RE/2833 GREAT BRAK RIVER – COMMENTS & RESPONSE TABLE

Megan Simons (CapeNature), 07 May 2024

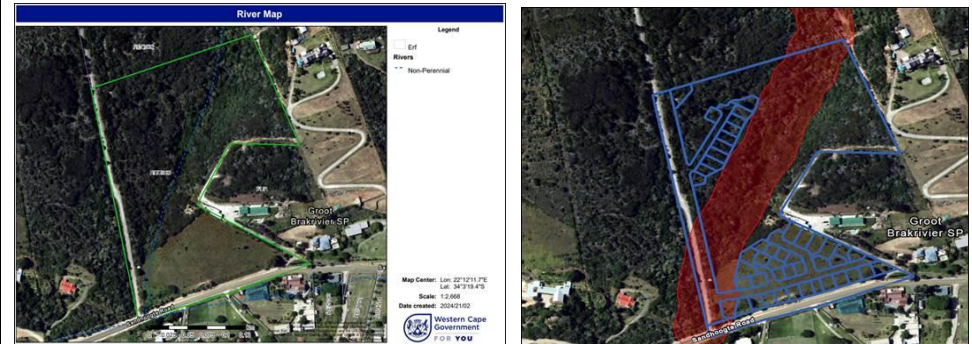
There seems to be an intermittent natural channel that traverses through the application property on the map. Please assess and delineate the extent of the watercourse to identify if the proposed development will trigger water uses in terms of the National Water Act, 1998.

According to the aquatic specialist (Dr Dabrowski from Confluent Environmental), the non-perennial drainage line traversing the property is not a natural watercourse given the lack of defined bed, banks or channel. The water also does not tend to stand or accumulate along this area given the lack of hydrophilic plant species and seasonal, temporary or permanent soil saturation. It is however a low point in the landscape (valley) with natural drainage and therefore serve a hydrological function.

The aquatic specialist delineated the low point and recommended a 30m buffer zone on either side of the lowest point along the valley bottom (please see attached Aquatic

Compliance Statement, 2023). This buffer zone is included in the Mitigated Site Development Plan (please see below):
